Engineering Review
04/16/2020 3:51:17 PM
dsdrice
JeffRice@elpasoco.com
(719) 520-7877
EPC Planning & Community
Development Department

RE: River Bend Crossing
City of Fountain, Colorado
Updated Traffic Impact and Access Analysis
LSC #184140

LSC Responses to PCD TIS Redlines dated April 16th 2020

Figure 18

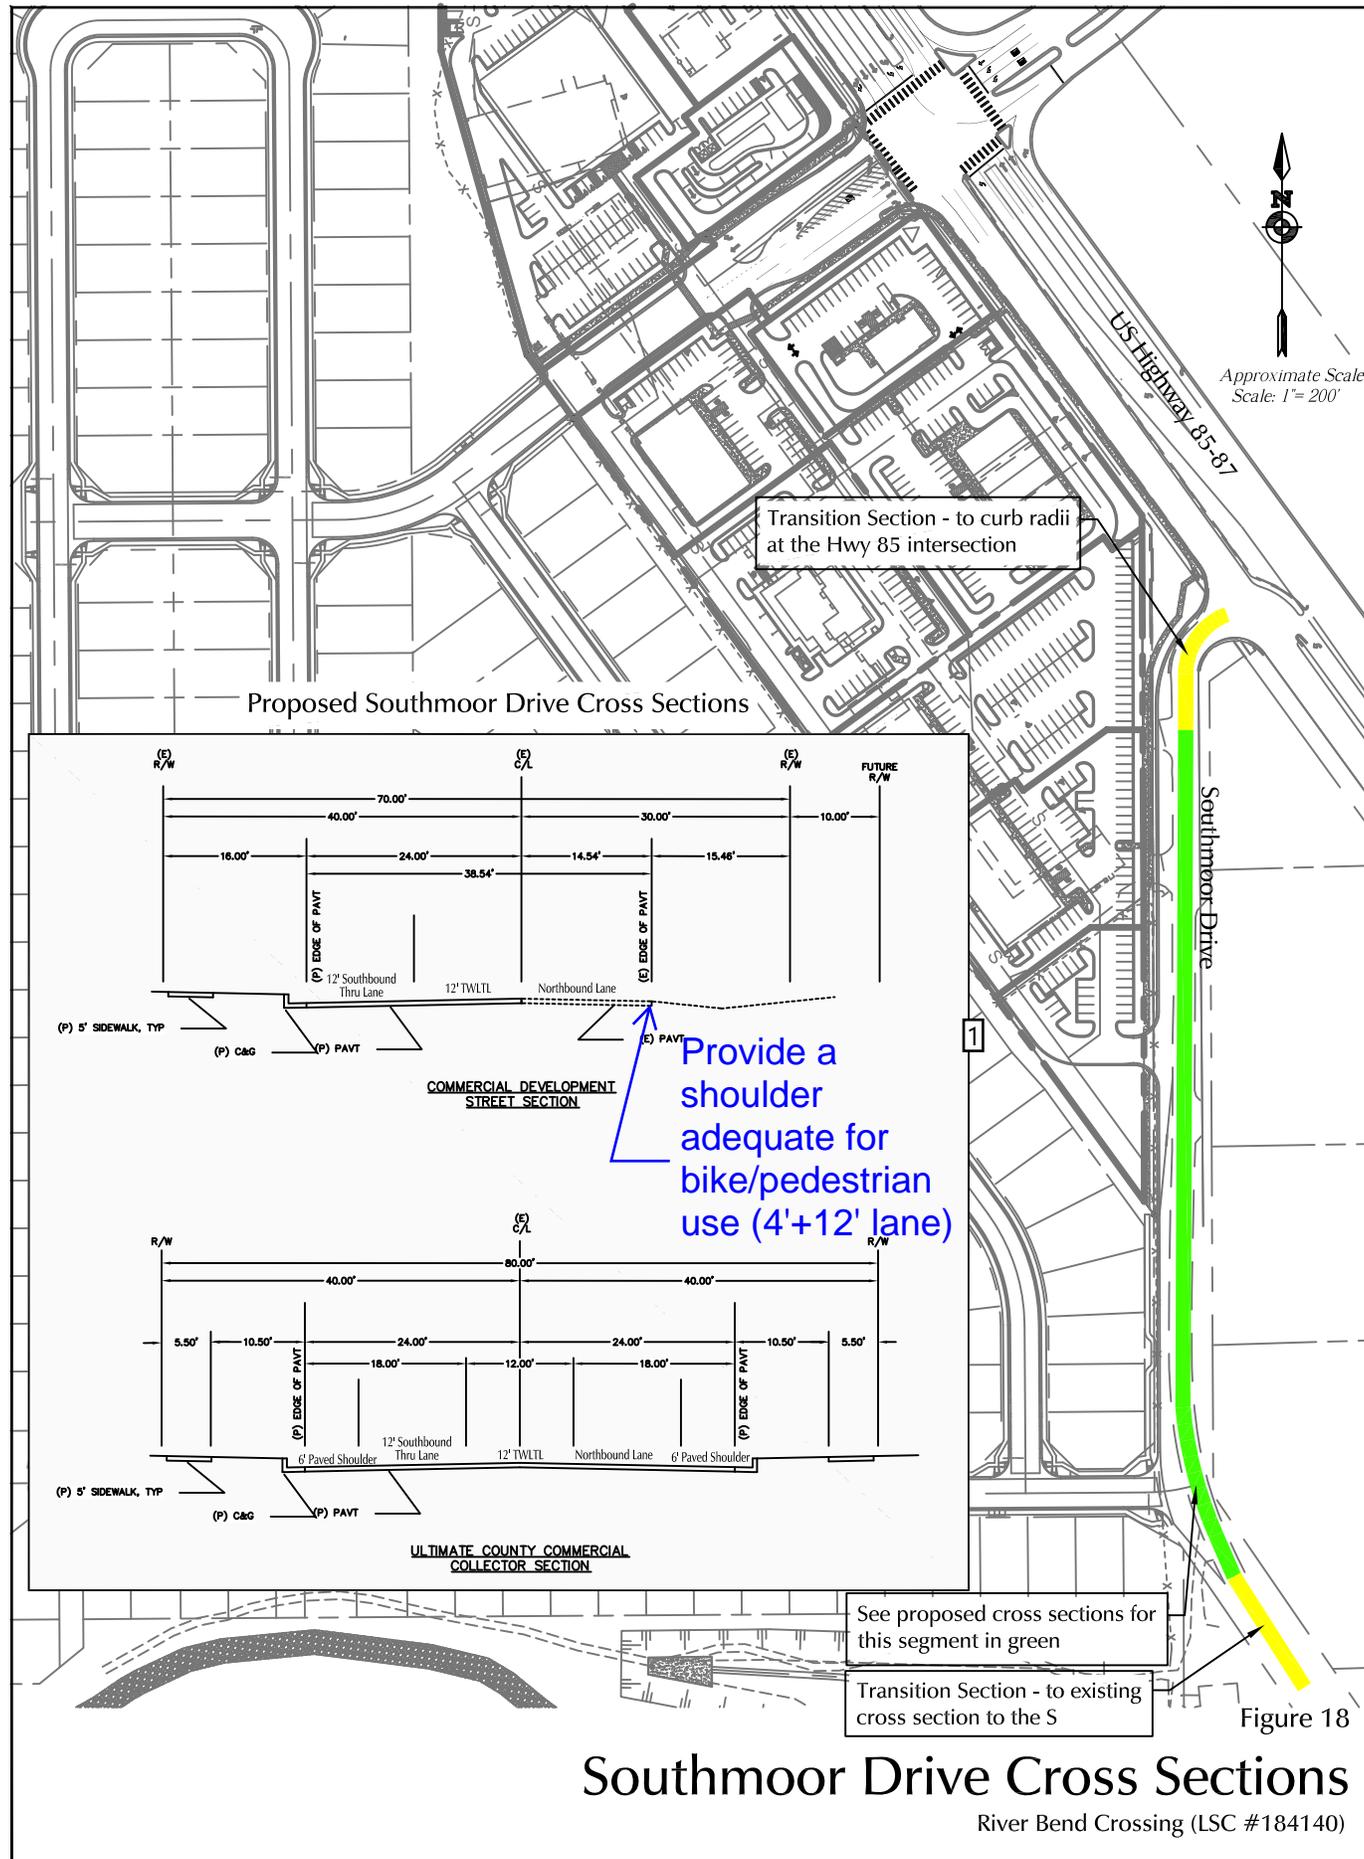
Provide a shoulder adequate for bike/pedestrian use (4'+12' lane)

Author: jchodsdon Subject: Sticky Note Date: 8/17/2020 12:16:57
LSC Response: Revised as requested.
